# **EXHIBIT F**

Project: PROPOSED SOLAR  
PHOTOVOLTAIC ARRAY  
270 PRESTON ROAD  
PLYMOUTH, CONNECTICUT

Sheet Title:  
ACCESS ROAD AND  
STORMWATER BASIN  
REVISION SKETCH

SHEET #:  
**EX-2**

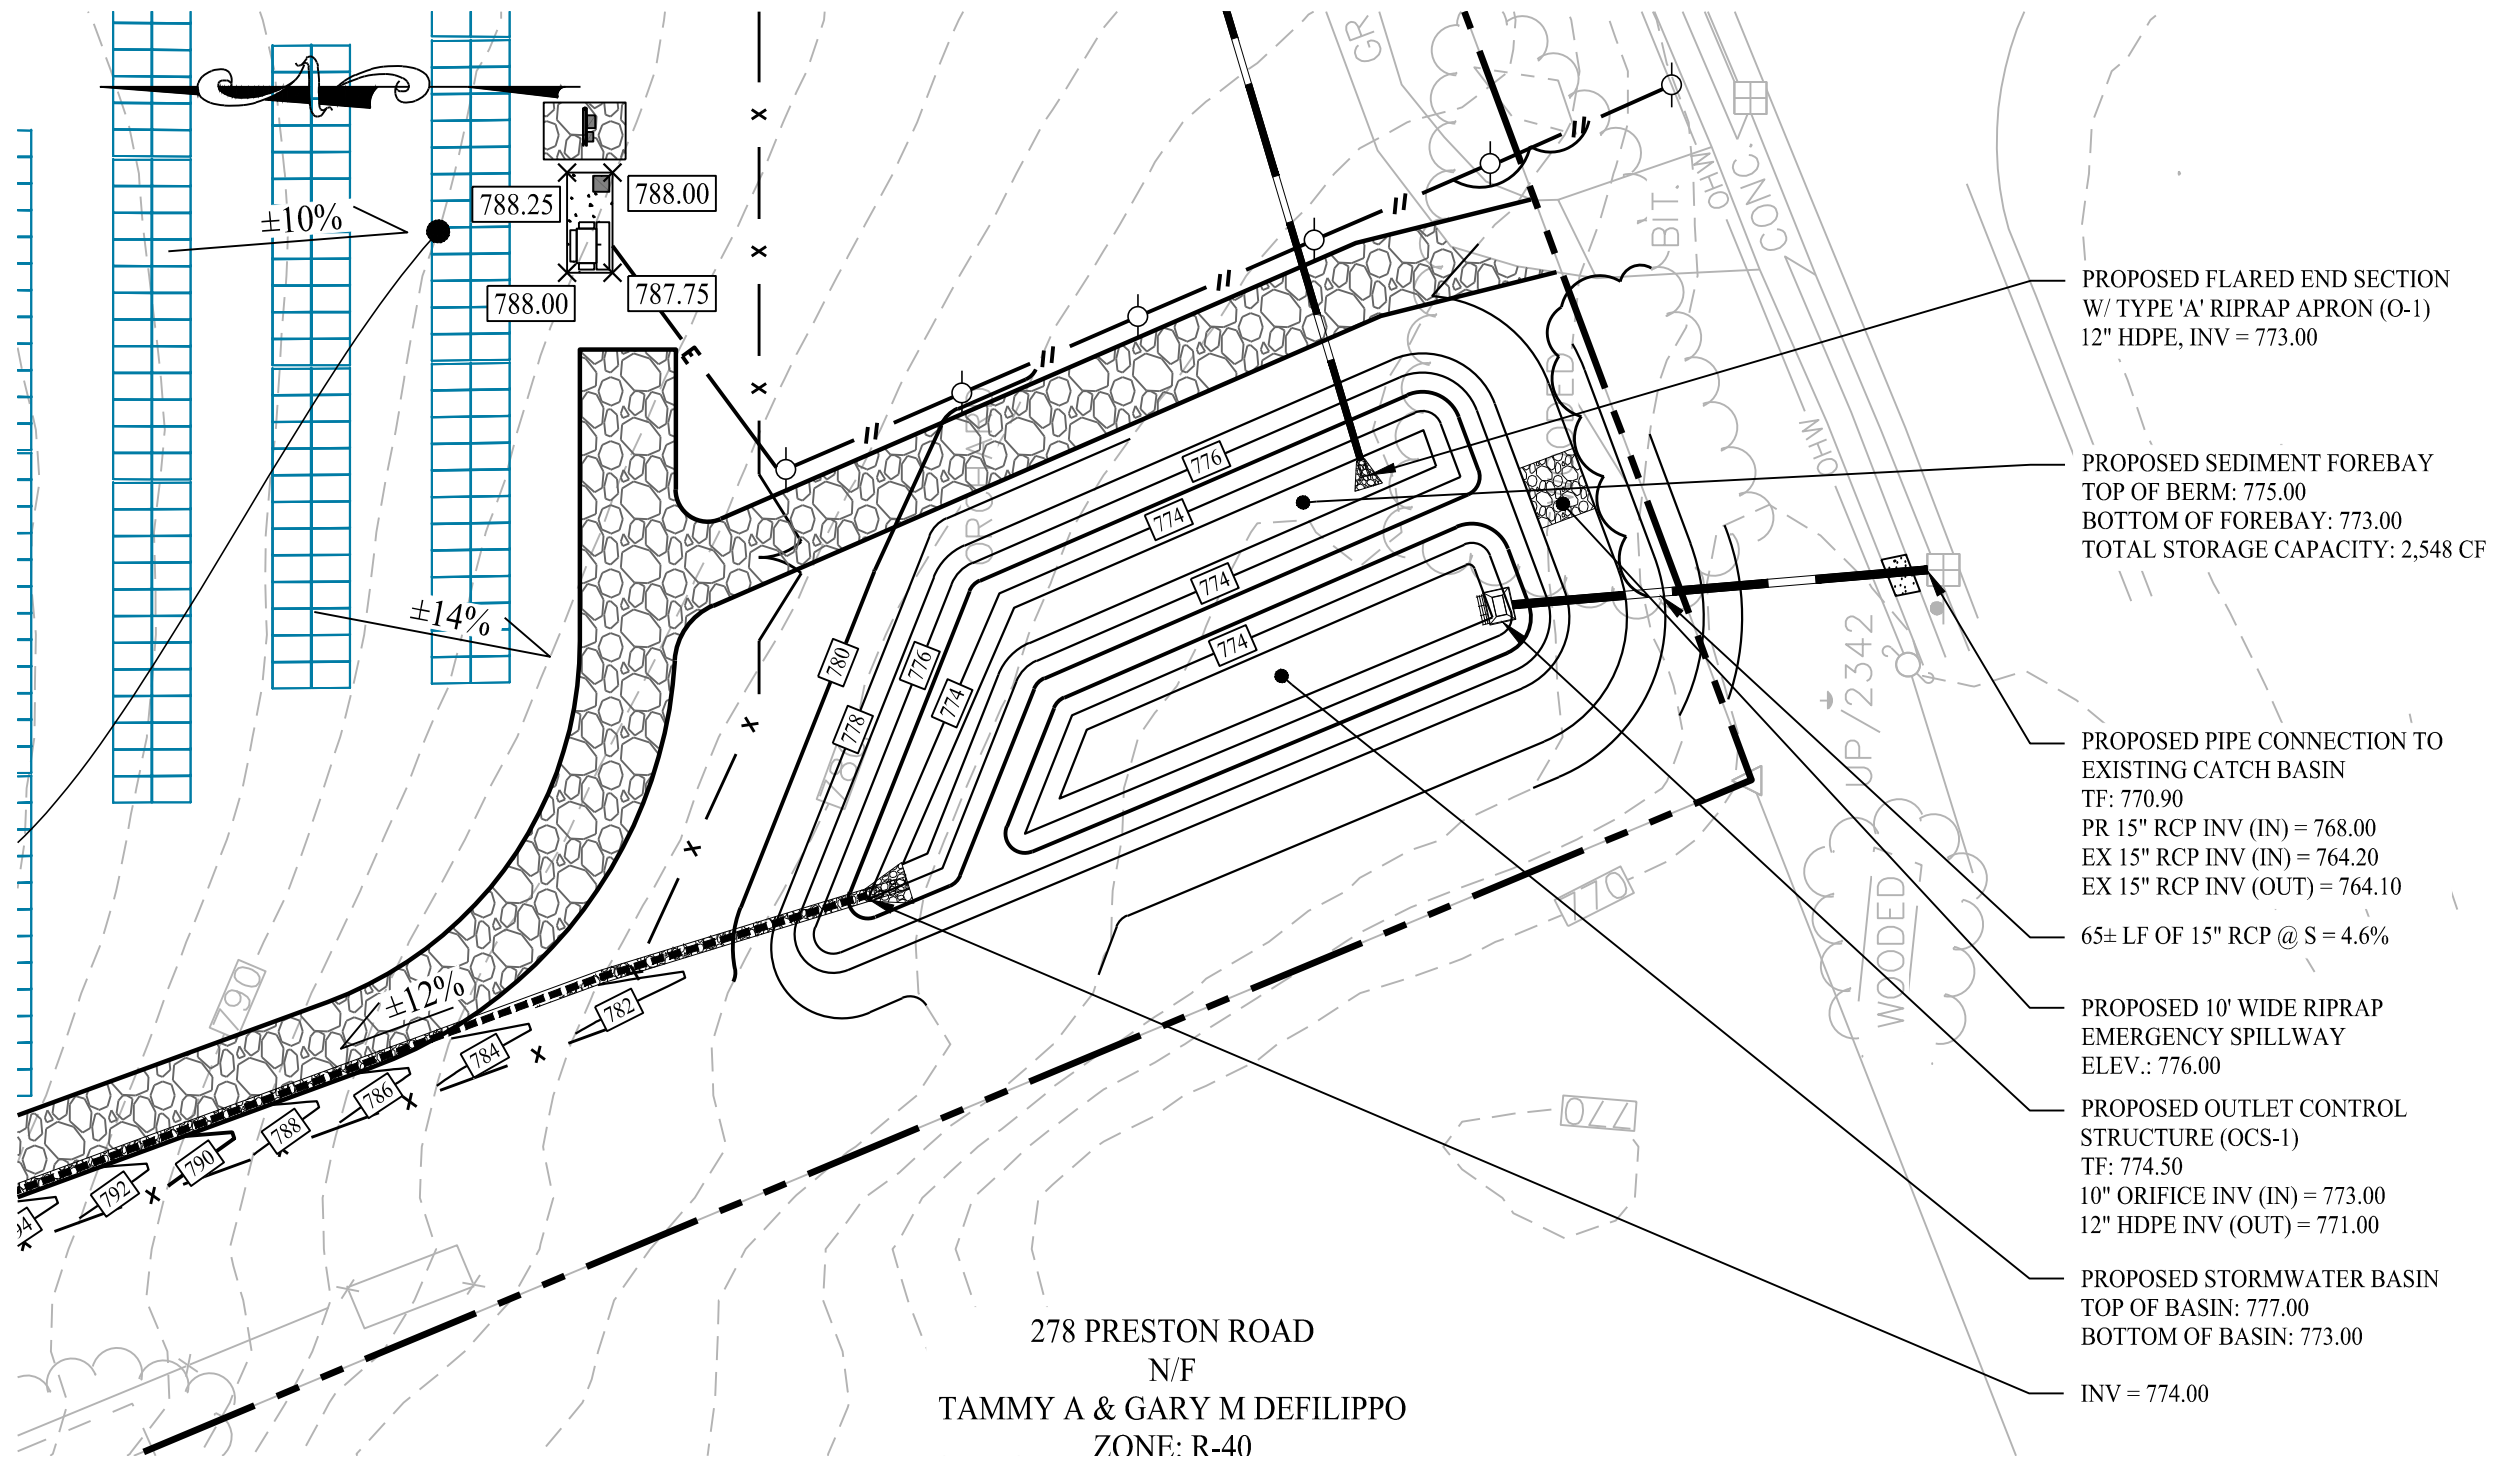
PROPOSED FLARED END SECTION  
W/ TYPE 'A' RIPRAP APRON (O-1)  
12" HDPE, INV = 773.00

PROPOSED SEDIMENT FOREBAY  
TOP OF BERM: 775.00  
BOTTOM OF FOREBAY: 773.00  
TOTAL STORAGE CAPACITY: 2,548 CF

PROPOSED PIPE CONNECTION TO  
EXISTING CATCH BASIN  
TF: 770.90  
PR 15" RCP INV (IN) = 768.00  
EX 15" RCP INV (IN) = 764.20  
EX 15" RCP INV (OUT) = 764.10

65± LF OF 15" RCP @ S = 4.6%

PROPOSED 10' WIDE RIPRAP  
EMERGENCY SPILLWAY  
ELEV.: 776.00

PROPOSED OUTLET CONTROL  
STRUCTURE (OCS-1)  
TF: 774.50  
10" ORIFICE INV (IN) = 773.00  
12" HDPE INV (OUT) = 771.00

PROPOSED STORMWATER BASIN  
TOP OF BASIN: 777.00  
BOTTOM OF BASIN: 773.00
